June 2023  
FL975A  
NHTSA #23V-348

## Subject: Turn Signal Indicator

**Models Affected: Specific model year 2023 Western Star 57X vehicles manufactured August 8, 2022, through January 18, 2023.**

Fig. 1, Downloading Data from the Server

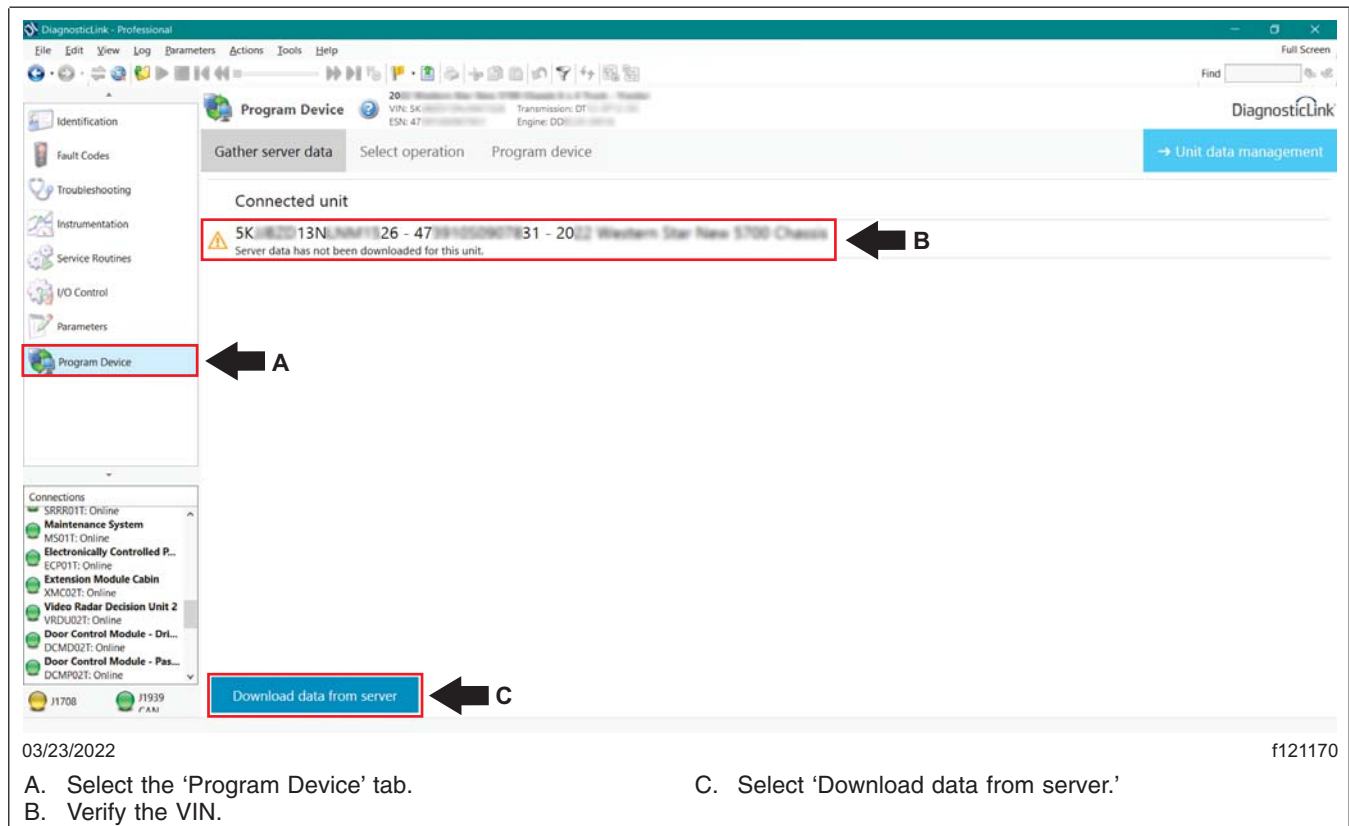
6. Go to the 'Program Device' tab, and make sure that the vehicle identification number (VIN) is correct. Select 'Download data from server.' See [Fig. 1](#).

Fig. 4, Writing the Parameter Changes to the Vehicle

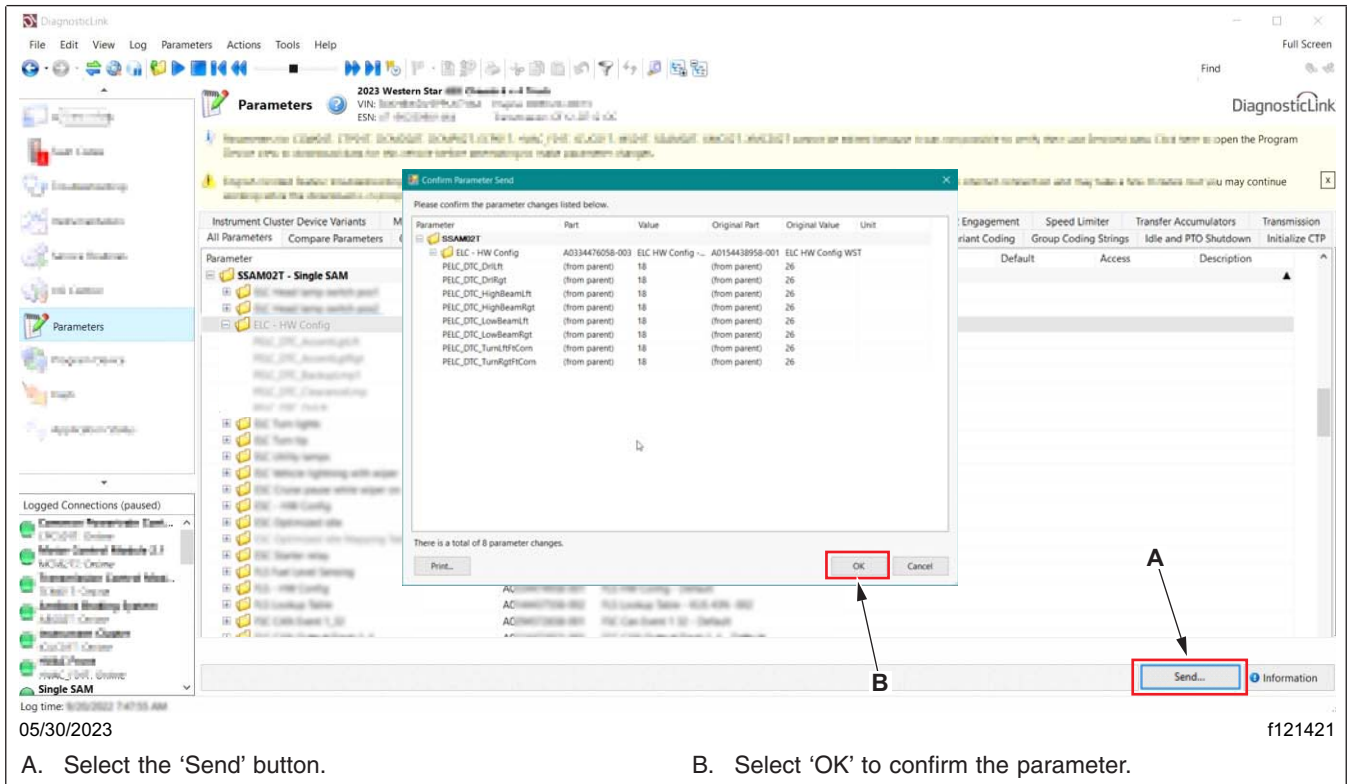
9. Select the 'Send' button to write the parameter change to the vehicle. A window will open asking to confirm the parameter change. Select 'OK.' See [Fig. 4](#)

A. Select the 'Send' button.

B. Select 'OK' to confirm the parameter.

**Fig. 6, Uploading the New Parameters**

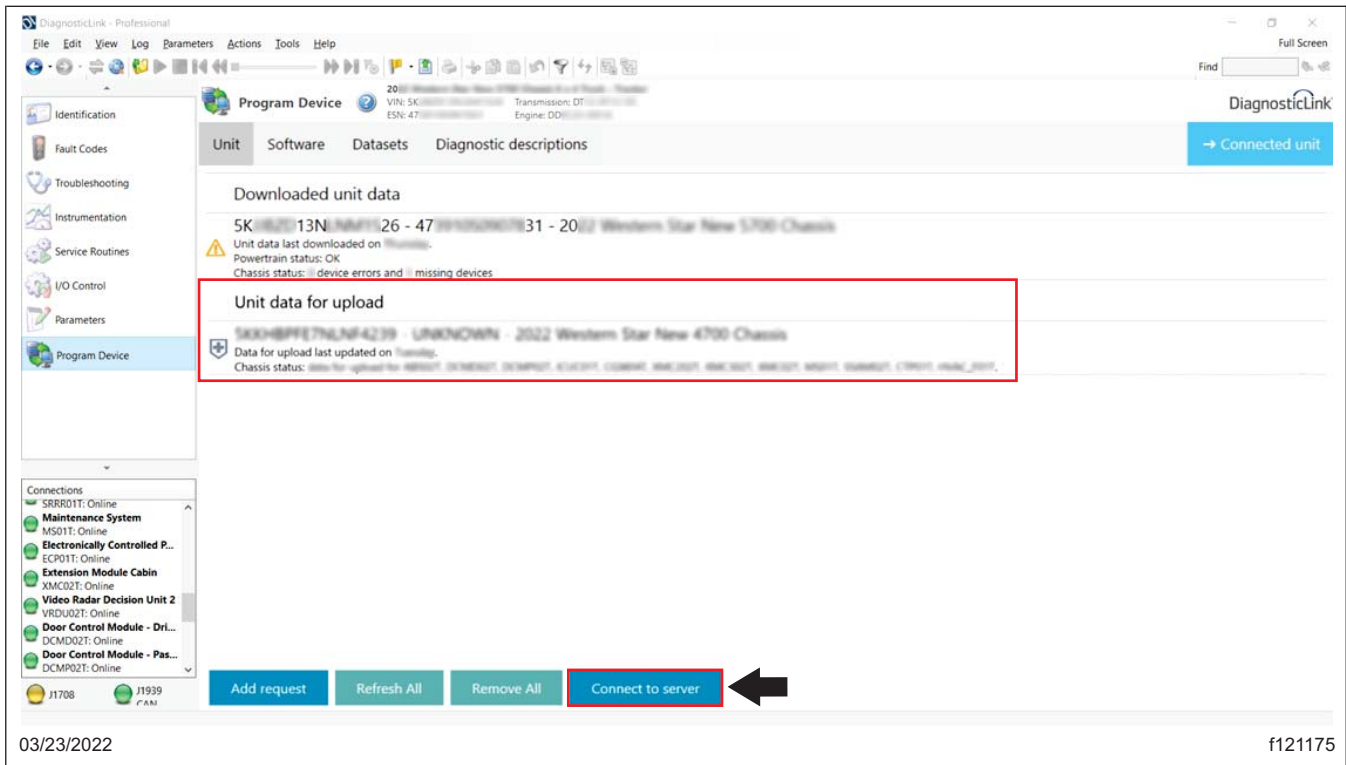
11. The information corresponding to the VIN should appear under 'Unit data for upload.' Select 'Connect to server' to upload the new parameters. See [Fig. 6](#).
